Change Notice

FT Series

Changes to ITO Film for FT Series Analog Resistive Touch Screens

Cross Section View of Touch Screen	Before Change	After Change
	<p>Surface Hardness: 2H (JIS K 5600)</p>	<p>Surface Hardness: 3H (JIS K 5400)</p>

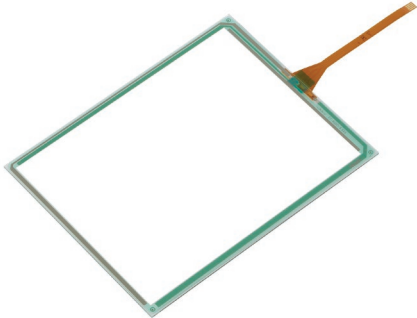
FT Series Touch Screens will be undergoing changes to the ITO film (top electrode). This revision will apply to the four-wire analog resistive touch screens, the four-wire analog resistive touch screens with FPC tails, and the five-wire analog resistive touch screens, both standard and custom models. The hardness of the film, previously 2H, will be changing to 3H. Details are highlighted on the following table.

This change does not impact the specifications or dimensions of FT Series Touch Screens. Contact information is below if more details are needed.
